# Access Compliance Report

## Public Rights-of-Way

Intersection ID: 47910	Main Street: ROOK_RD	Cross Street: MOUNTAIN_QUAIL_DR	Location:	N
ADA ID: 25C6F4E69DD9	Ramp Type: PerpDiag	Initial Pass/Fail: Fail	Overall Compliance: No	Severity Score: 22.5
Codes/Mitigation Info/Possible Solution		Field Measurements/Component Compliance

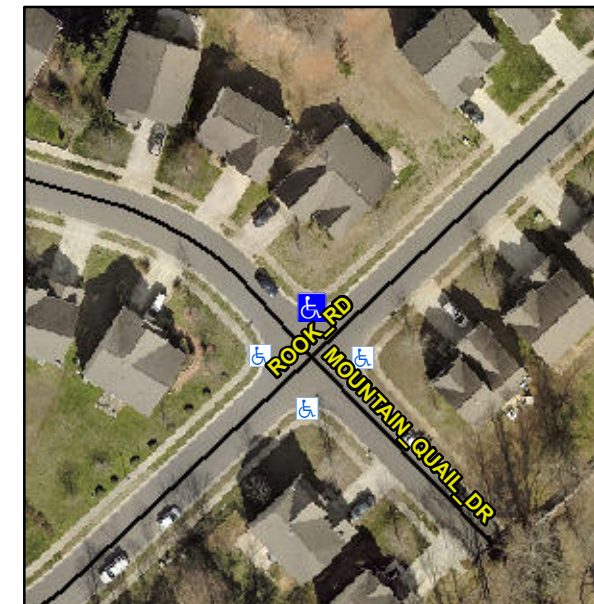
**Not Found, R304.5.1, R304.2.2, R304.5.3**

Compliance	Description	Data	Compliance	Description	Data
N/A	Ramp Length (in)	52.0	No	Ramp Slope (%)	8.5
No	Ramp Width (in)	40.0	No	Ramp XSlope (%)	3.5
N/A	Flare Type LT	N/A	N/A	Flare Type RT	N/A
N/A	Flare Slope LT (%)	N/A	N/A	Flare Slope RT (%)	N/A
N/A	Flare Traversable LT?	N/A	N/A	Flare Traversable RT?	N/A
N/A	Landing Length (in)	N/A	N/A	DWS Provided?	N/A
N/A	Landing Width (in)	N/A	N/A	DWS Contrast?	N/A
N/A	Landing Slope (%)	N/A	N/A	DWS Length (in)	N/A
N/A	Landing X Slope (%)	N/A	N/A	DWS Full Width?	N/A
N/A	Landing Curb? (Y/N)	N/A	N/A	DWS Offset (in)	N/A
N/A	Shared Landing?	N/A			
N/A	Gutter Ponding?	N/A	N/A	Gutter Slope (%)	N/A
N/A	Gutter Lip Ht (in)	N/A	N/A	Gutter X Slope (%)	N/A
N/A	Painted X Walk1?	No	N/A	Painted X Walk2?	No
	X Walk 1 Direction	To SW		X Walk 2 Direction	To SE
N/A	X Walk 1 Width (in)	N/A	N/A	X Walk 2 Width (in)	N/A
	X Walk 1 Slope (%)	0.3		X Walk 2 Slope (%)	3.7
	X Walk 1 X Slope (%)	3.3		X Walk 2 X Slope (%)	0.6

**Remove & Replace Curb Ramp With Two New Directional Ramps or Equivalent.**
